STATE OF NEVADA COMMENTS  
ON THE  
U.S. DEPARTMENT OF ENERGY  
SITE CHARACTERIZATION PLAN  
YUCCA MOUNTAIN SITE  
NEVADA  
VOLUME I

STATE OF NEVADA COMMENTS  
ON THE  
U.S. DEPARTMENT OF ENERGY  
SITE CHARACTERIZATION PLAN  
YUCCA MOUNTAIN SITE  
NEVADA  
VOLUME I

SEPTEMBER 1989

Pages 3-216 to 219. Ground-water travel time in the unsaturated zone

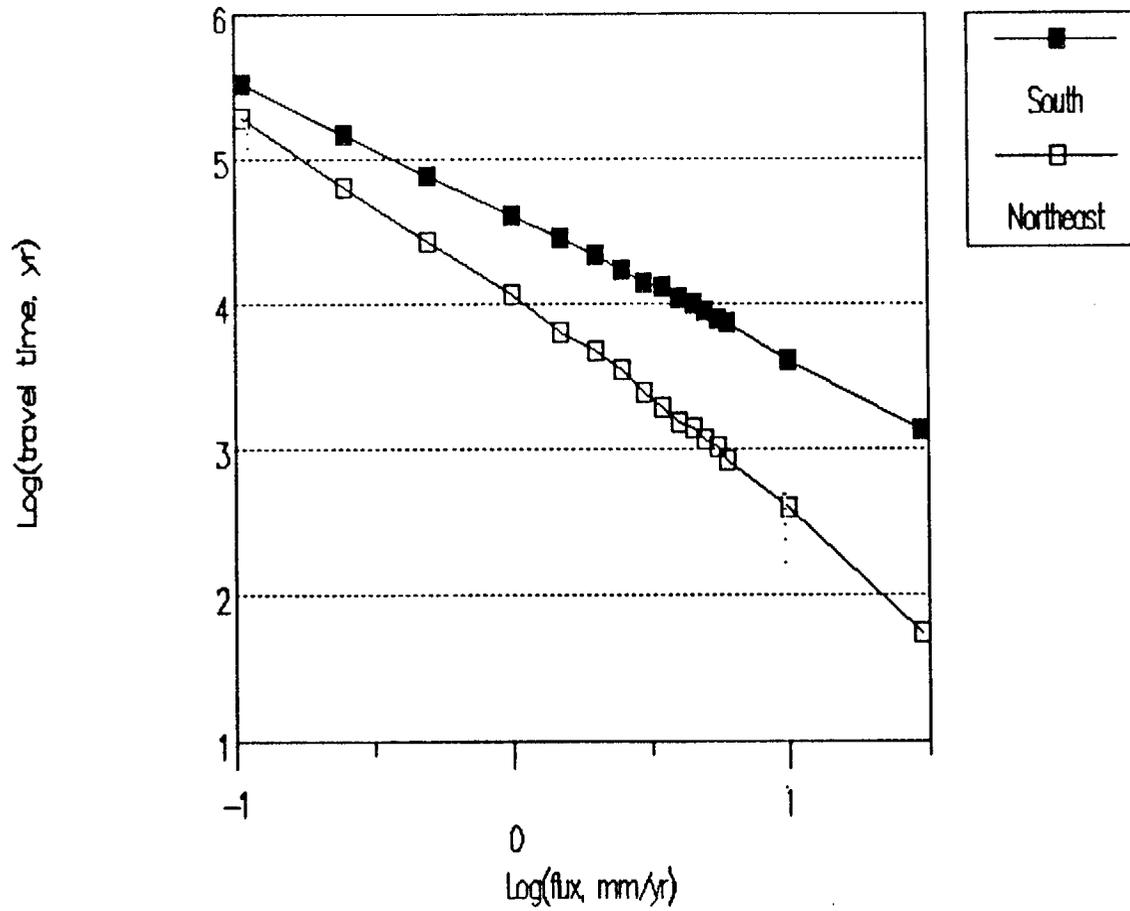
The results of the modeling study of Lin, Y. T., M. S. Tierney, and S. Sinnock, 1986. Preliminary Estimates of Groundwater Travel Time and Radionuclide Transport at the Yucca Mountain Repository site, SAND85-2701, are summarized. The study is also the basis of section 8.3.5.12.

The model is very preliminary and appears to have been published hurriedly in support of the Environmental Assessment and the consultation draft SCP. The model allows for fracture flow if the flux is greater than the matrix hydraulic conductivity. The model is labeled as stochastic since the thicknesses of the formations between the repository horizon and the water table are sliced into layers, the porosity and hydraulic conductivity of which are sampled randomly from a normal and a log-normal distribution. The study contains travel time calculations for the two flux values of 0.5 and 1.0 mm/yr only.

The model uses average hydraulic conductivity values of 0.722, 107.2, 0.535, 87.7, 21.6, 118.4, and 21.6 mm/yr for the TSw, CHnv, CHnz, PPw, PPn, BFW, and BFn formations respectively. Since fracture flow can occur only if the flux is greater than the matrix hydraulic conductivity, the model allows effectively for fracture flow in the TSw and CHnz formations only. But even in the TSw and CHnz formations, because the hydraulic conductivity is sampled from a log-normal distribution, there will always be layers that favor matrix flow over fracture flow even at flux values of 5 mm/yr. The ground-water travel time (GWTT) through a 10 m layer favoring matrix flow is always several hundred years and sometimes even closer to 1,000 yr. It only takes one or two 10 m layers favoring matrix flow to have a GWTT of over 1,000 yr even for a flux value of 5 mm/yr.
